# CITY OF KODIAK

LANDSCAPE MASTER PLAN July 2010

#### **KODIAK CITY COUNCIL WORK SESSION COMMENTS**

#### THE MALL

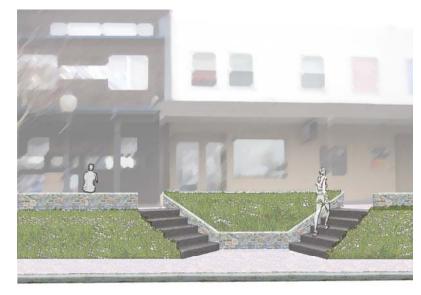
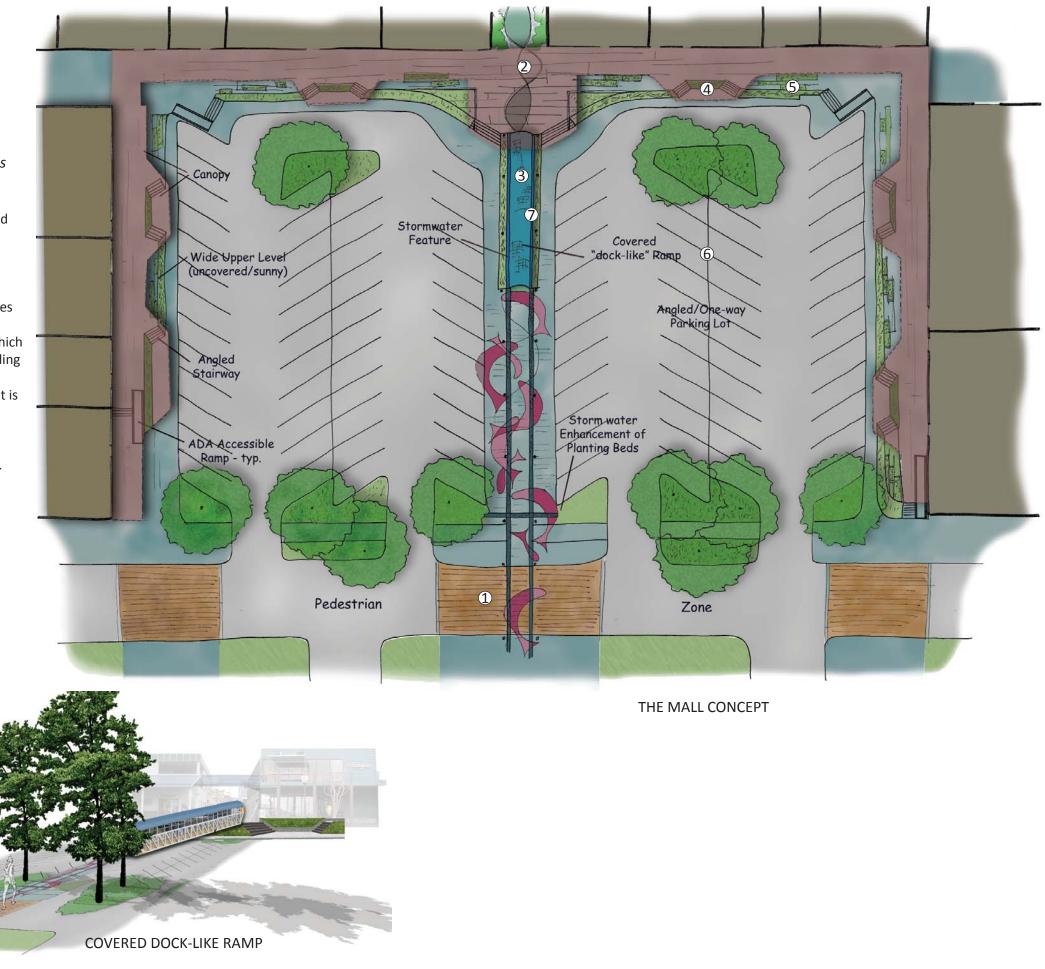
Comment Summary
Mall
The concept plan for the Mall area (pg. 15) shows the removal of tramps. A majority of the stairs have been covered to protect them central walkway has been incorporated - this allows for enhanced has been incorporated and the number of parking spaces has inc
Remove the rock walls. The steep slopes are dangerous for people to walk of ock wall to a terrace and extend the walkway level for planting beds or a side should be textured with fish and boats or a tidal wave scene.
Shrink the area for planting and increase area for parking.
There needs to be handicap access. (2)
Stairways need to be wider. (2)
Need for more stairways. (2)
Slippery in winter.
Heated sidewalks.
There are trip hazards from old and uneven cracked sidewalks.
There should be an opportunity to spruce up the surrounding buildings at the
Omit any trees near buildings.
Retain the area for delivery.
There should be a pedestrian sidewalk through the center of the mall parking center walkways need to be removed.

Fhere should be angled parking.
The northwest end of the parking lot is too narrow for a corridor.
The alley northwest of the mall should be cleaned up. Lighting should be provoulding paint should be improved.
ce removal in the winter.
Sand/gravel removal in the spring.
ncorporate design features such as decorative lighting, meandering stream, extured sidewalks.
The alleyways behind the mall buildings are ugly, uncared for, create wind tur inwelcoming.
mprove the streets behind the mall - one way/speed bumps.

those walls and develops more and wider stairs as well as accessible m from the weather. Two islands in the lot have been removed and a d pedestrian access and makes snow plowing easier. Angled parking creased (pg. 18).

on. Build up the lewalk. The wall	See above - walls have been removed and the master plan includes covered stairs up to the shops/restaurants, improved planter beds, and widened walkways at the arcade level.
	See above - parking has increased.
	See above - accessible ramps have been included.
	See above - wider stairs have been included.
	See above - more stairs are included.
	See above - covered stairways have been included.
	Suggestion noted, but this is out of the scope of the project. This comment will be passed on to appropriate City staff.
	See above.
e same time.	This landscape master plan addresses the overall street character. Design criteria for storefronts are beyond the scope of this project. However, it is hoped that as the streetscape is improved, local businesses will be motivated to improve their appearance as well.
	See above.
	See above.
g lot. The two, off-	This has been incorporated into the Mall area concept (pg. 15).
